General Electric Company  
175 Capital Avenue, San Jose, CA 95128

MFN No. 038-92  
Docket No. STN 50-605  
EEN-9224

Subject: **GE Response to Agenda Items Discussed During the GE/NRC  
Reactor Systems Branch Meeting on November 20-21, 1991**

Enclosed are thirty-four (34) copies of the GE response to the subject discussion items, numbered 3,6,7 and 17.

Figure 7-1 WATER LEVEL IN FUEL CHANNELS FOLLOWING A MAIN STEAMLIN  
 BREAK OUTSIDE CONTAINMENT, NO HIGH PRESSURE ECCS AVAILABLE  
 (REALISTIC ANALYSIS ASSUMPTIONS)

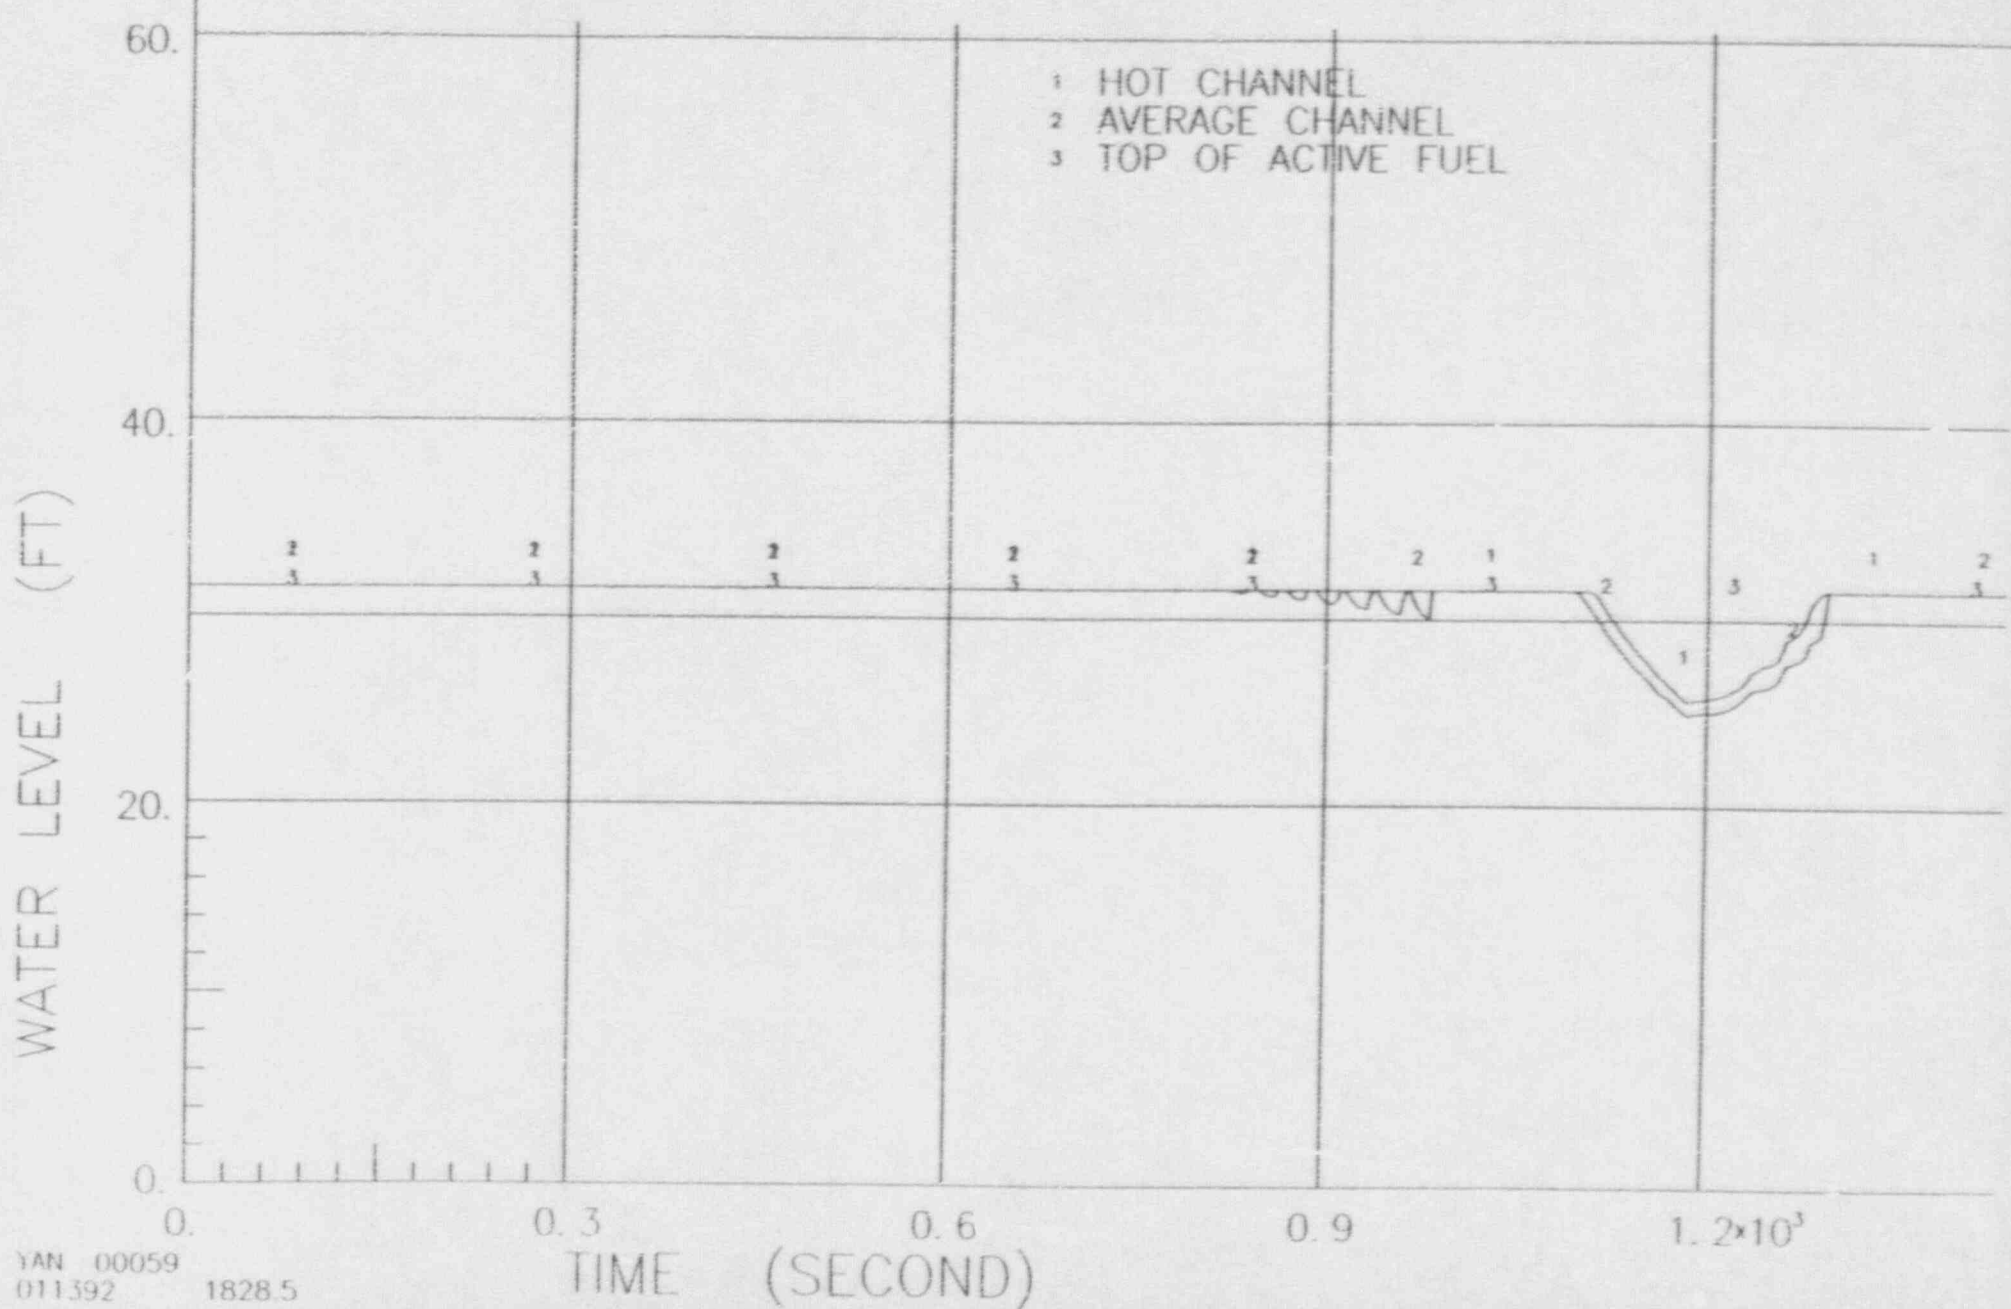
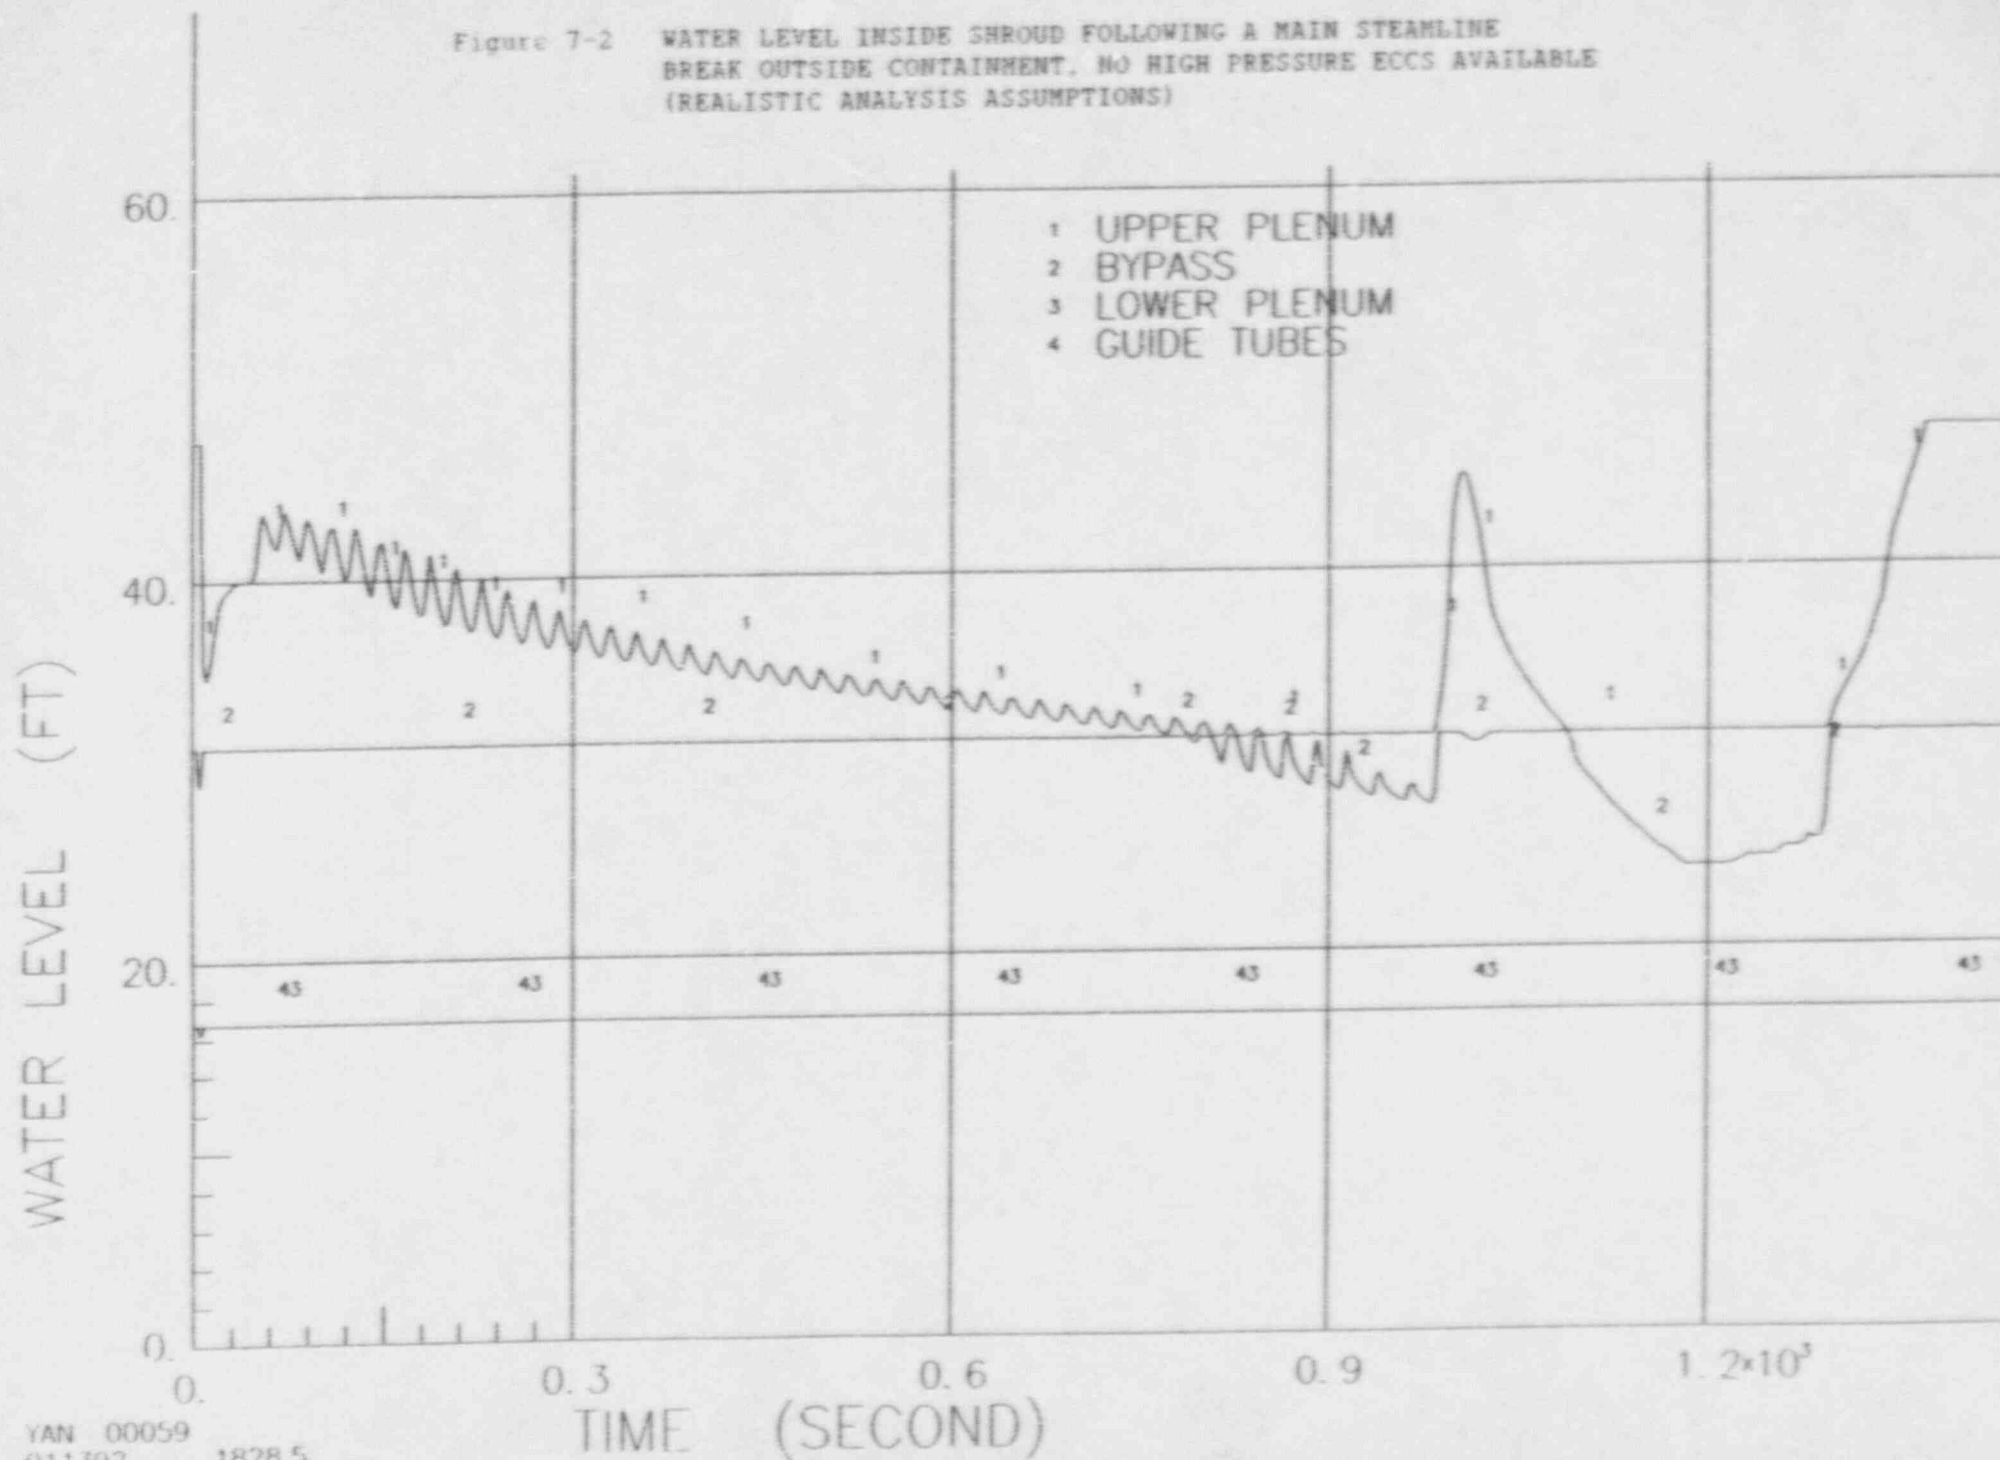
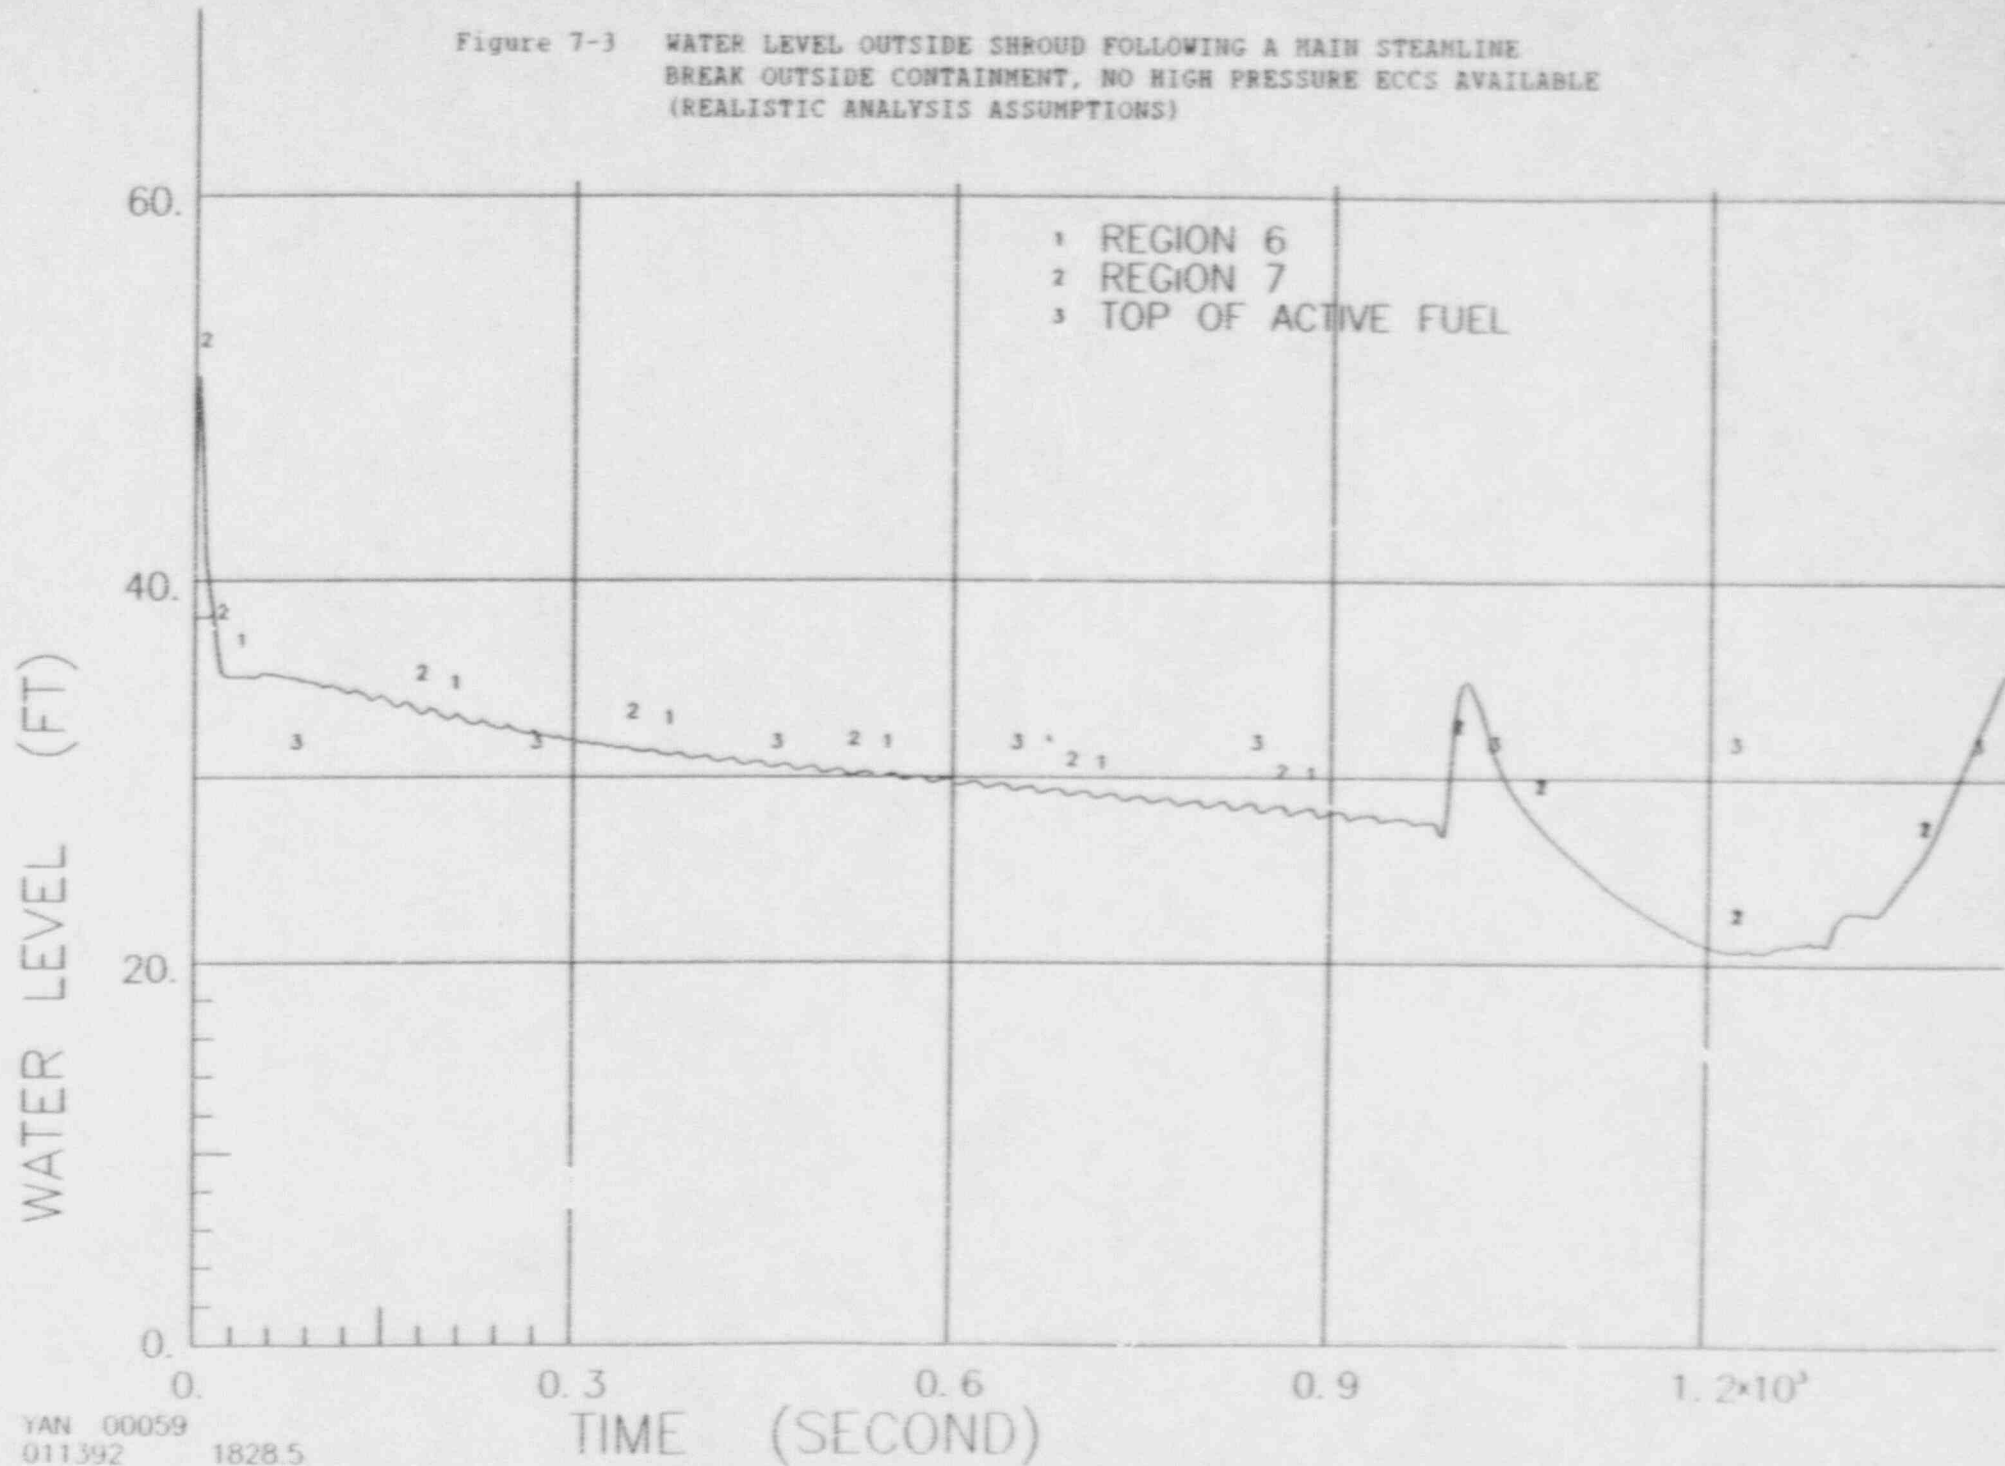
An 8 minute high drywell pressure bypass timer has been added to the ADS initiation logic to address TMI action item II.K.3.18. This timer will initiate on a Low Water Level 1 signal. When it times out, it bypasses the need for a high drywell signal to initiate the standard ADS initiation logic.

For all LOCAs inside the containment, a high drywell signal will be present and ADS will actuate 29 seconds after a Low Water Level 1 signal is reached. All LOCAs outside the containment become rapidly isolated and any one of the three high pressure ECCS can control the water level. The high drywell pressure bypass timer in the ADS initiation logic will only affect the LOCA response if all high pressure ECCS fail following a break outside the containment. For this case the ADS will automatically initiate within 50 seconds (8 minute timer plus 29 second standard ADS logic delay) following a Low Water Level 1 signal.

An analysis was performed to evaluate the adequacy of the 8 minute bypass timer. As discussed above this analysis involves multiple failures. Therefore it is part of the PRA success criteria realistic LOCA evaluation. The main difference between the input assumptions for this case and those in Section 6.3.3 of the SSAR is the use of a realistic decay heat curve (i.e. ANS 5.1). A complete circumferential break of the main steamline outside the containment (which is representative of those LOCA cases where no high drywell signal is present.) was evaluated. The key results from this analysis are given in Figures 7-1 through 7-7. The peak cladding temperature (PCT), refer to Figure 7-7, for this case is less than 1100°F which is well below the 2200 °F licensing limit. This PCT is due to the initial voiding in the core at the beginning of the event as in the case of the design basis evaluation. The heatup caused by the core uncover late in the event is negligible. These results confirm the acceptability of the 8 minute high drywell pressure bypass timer.
